ADMINISTRATIVE DEVELOPMENT PLAN AMENDMENT  
 FILE NO. 1000493-02236-00175  
 See note 7  
 Planning Director Date

1000493 Cottonwood Trails

SITE PLAN FOR SUBDIVISION AND BUILDING PERMIT

Consensus Planning January 10, 2001 Revised: February 13, 2002 Sheet 1 of 8

OPEN SPACE WALL/FENCE PLAN  
**SHEET 3B**

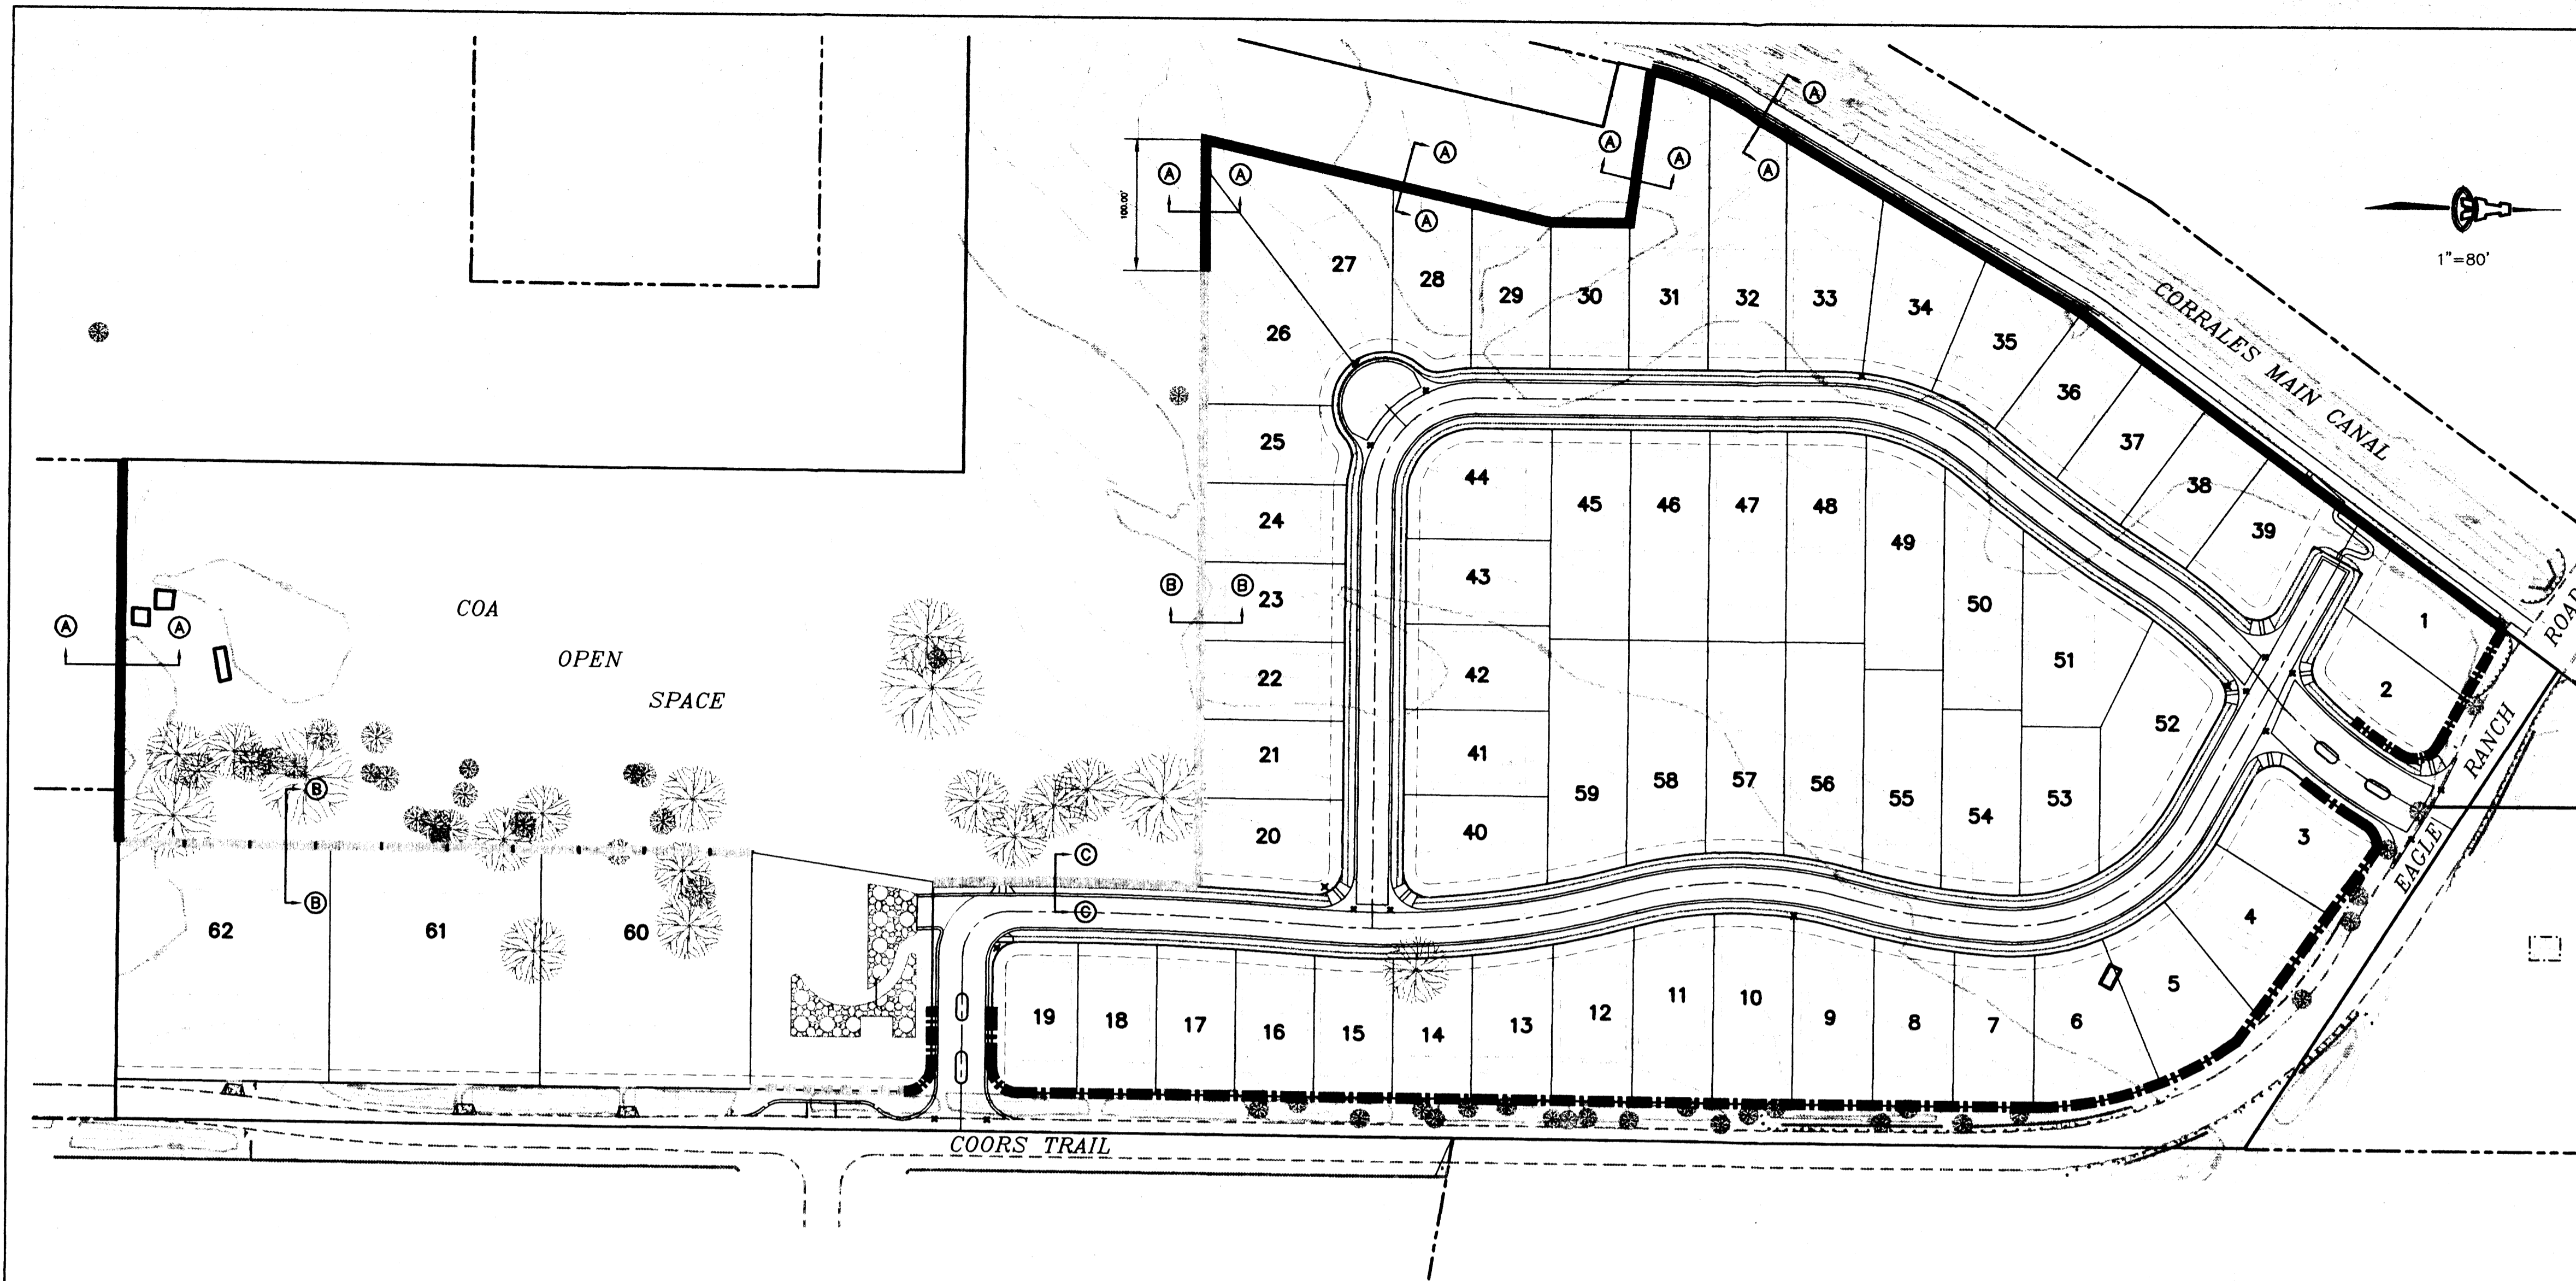
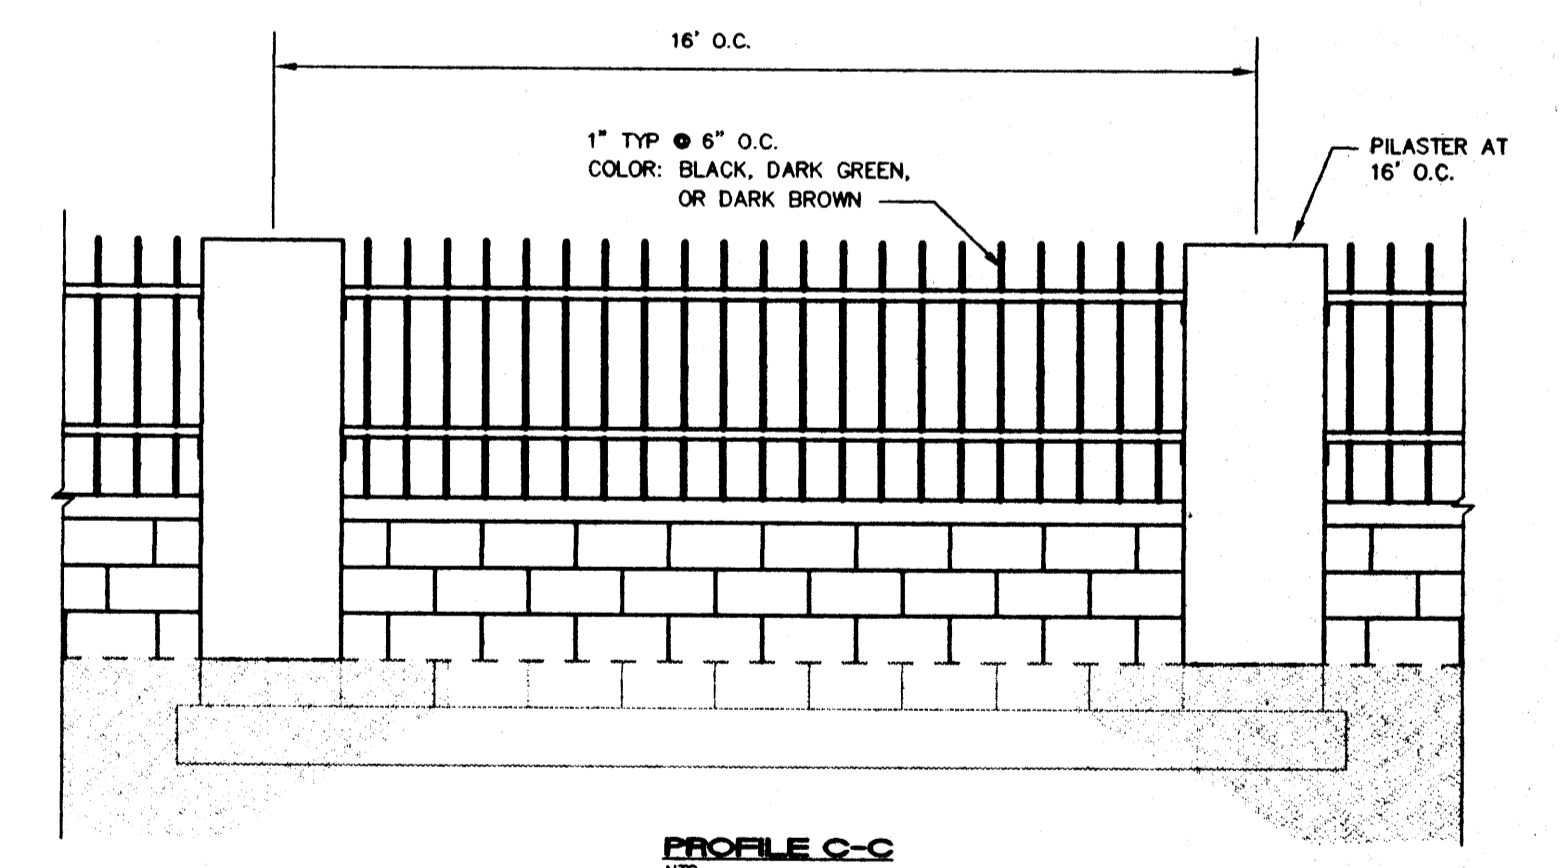
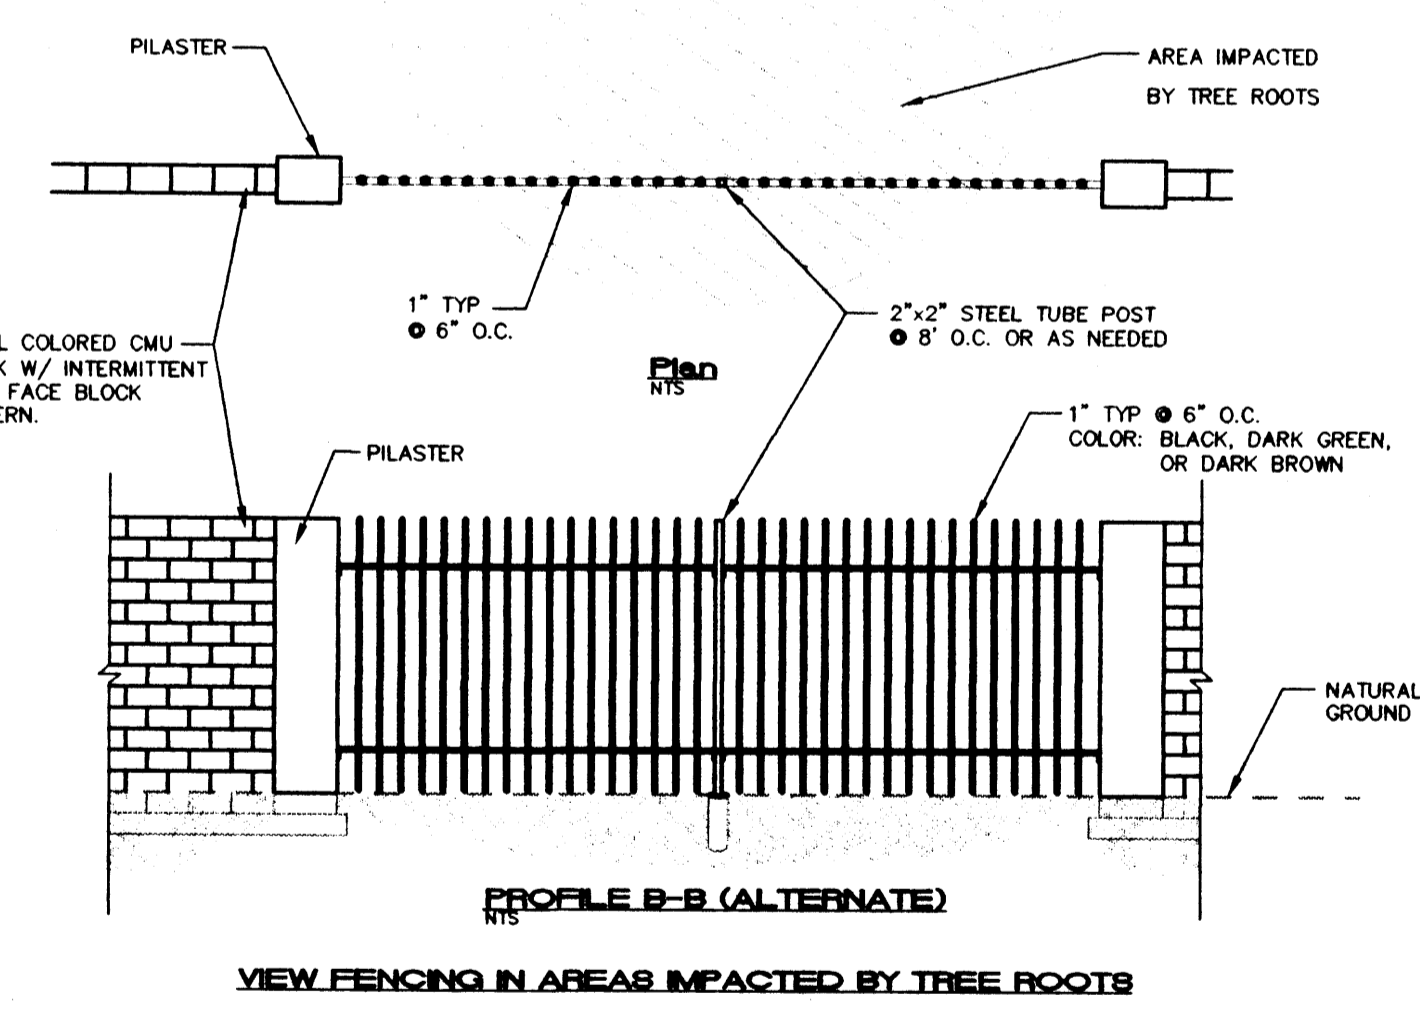
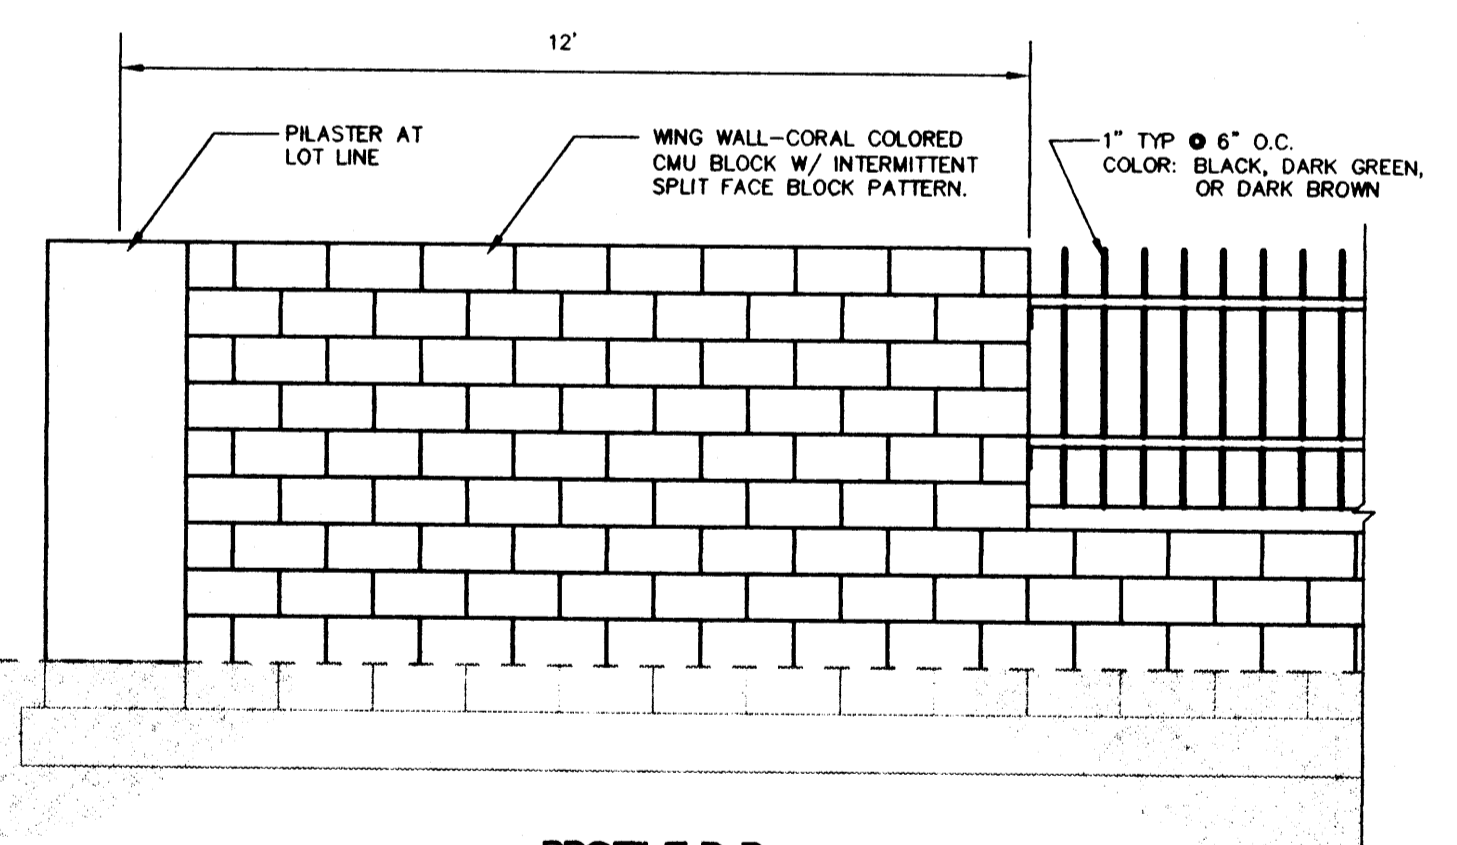
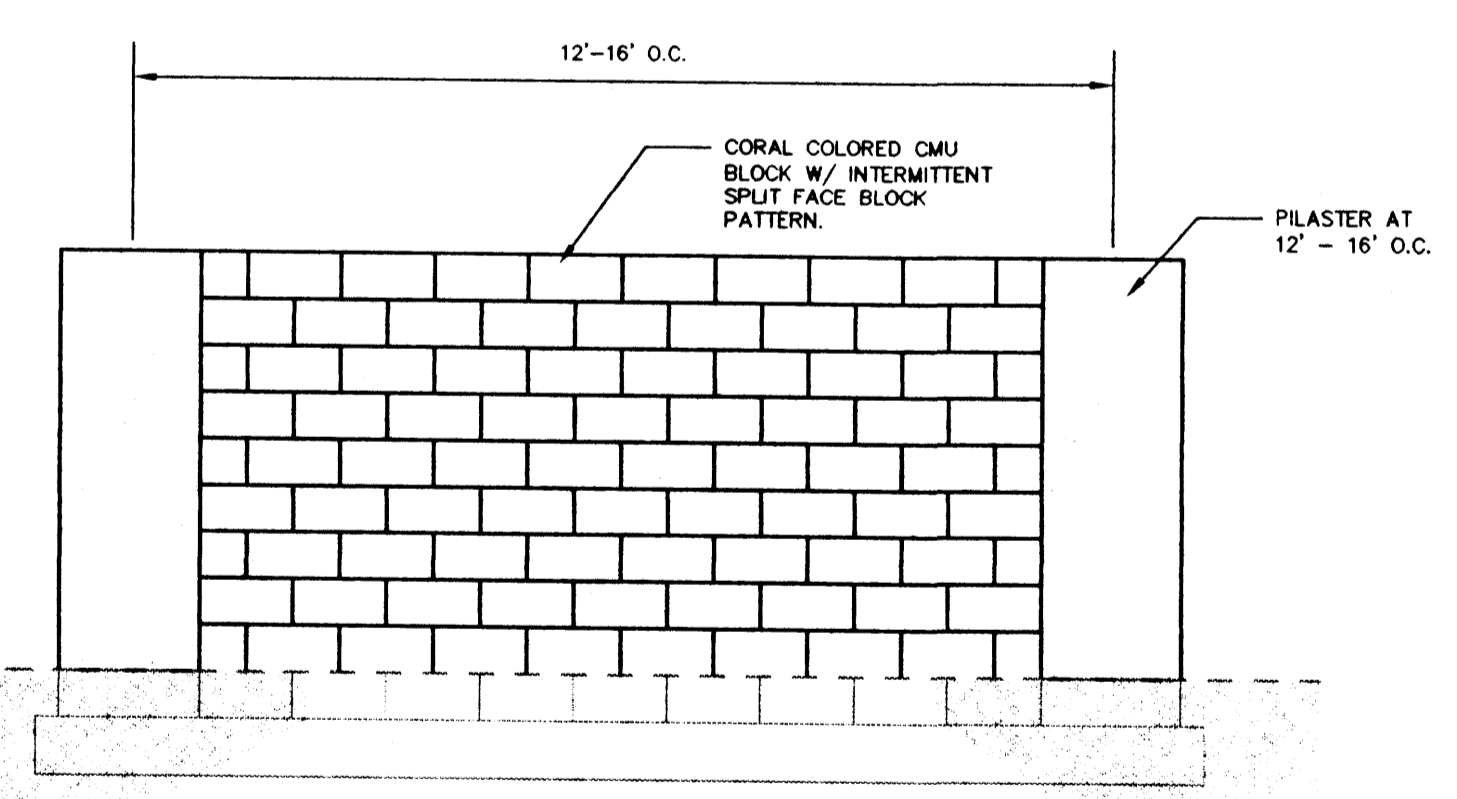
- Administrative Amendment
- Revised wall adjacent to City Open Space (Lots 18-26 & 60-62) to allow wrought iron view fencing (see new Sheet 3B).
- Added section of Open Space wall along the west side of Santo Lina Place (see Sheet 1).
- Revised note regarding existing cottonwood in the detention pond (see Sheets 2 & 3).
- Added Sheet 3B, Open Space Wall/Fence Plan.
- Modified Emergency Access per City DRC requirements (see Sheet 3).
